Inspection of gap between the elevator root hinge assembly and the vertical stabilizer skin.

All aircraft WT-9 Dynamic from S/N DY-672 to DY-696 (inclusive), DY-699, from DY-701 to DY-704 (inclusive).

Fig. 1

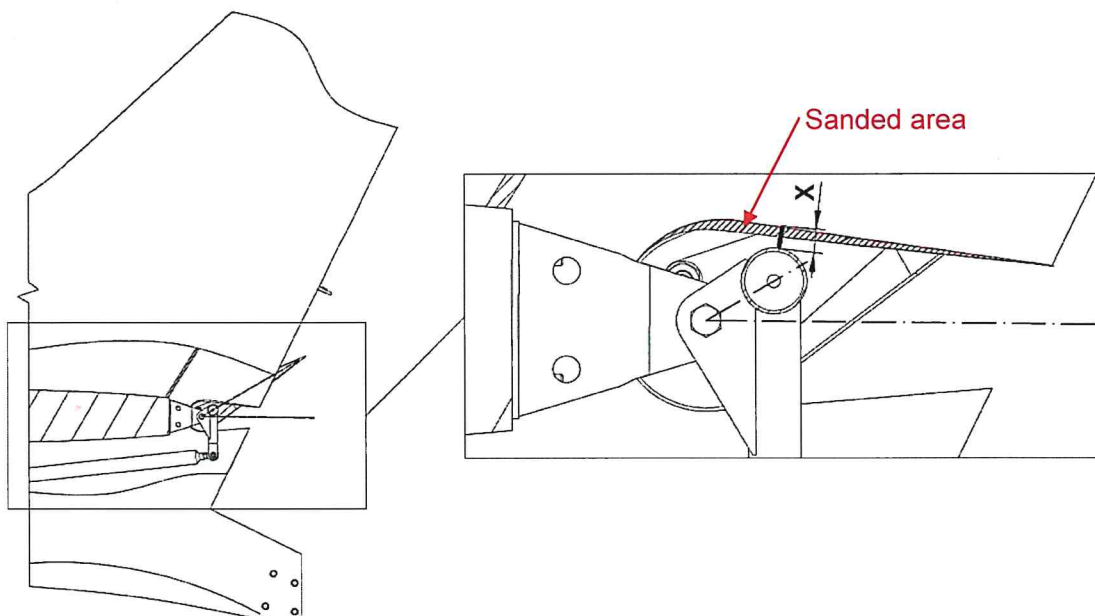
In operation it was observed that the root hinge assembly may come into contact with the cut-out edge of the vertical stabilizer skin at maximum up deflection of elevator. This will result in local minor damage of the skin at the contact point.

1. Set the elevator trim to full aft position (aircraft tail heavy) and fix the control stick at the rear stop (elevator deflection 30° up) with the help of an assistant or by other appropriate means.
2. Visually inspect the gap "X" between the elevator root hinge assembly and the upper cut-out edge of the vertical stabilizer skin (Fig. 1). The minimum gap "X" is 2 mm.

If a smaller gap is found, perform the following procedure:

3. Set the elevator trim to full forward position (aircraft nose heavy) and fix the control stick at the forward stop (elevator deflection 20° down) to gain access to the work area.

4. Protect the elevator root hinge bearing by appropriate means to prevent debris from getting into the bearing.
5. Sand the edge of the vertical stabilizer skin using sandpaper (grit 120) until the prescribed gap "X" is ensured (Fig. 1).
6. Clean the sanded area and remove debris.
7. Remove the protection of the elevator root hinge bearing.
8. Release the control stick from the fixed position.
9. Record the compliance with this bulletin into aircraft documentation.
